L4437A-01

# S E R V I C E N O T E

# L4437A General Purpose Switch

Instrument cannot operate in 400 Hz

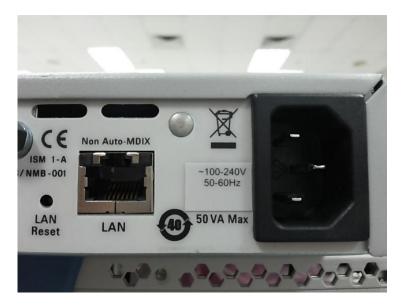
It has been found that the instruments with affected serial numbers listed above have incorrect information printed on the power rating label. The instrument does NOT support 400 Hz operation at 100-127V.

Order a L4421-84303 L44xxA Power Rating Label and apply it over the existing power rating information on the instrument. After applying the L4421-84303 label, it should look similar to the picture below.
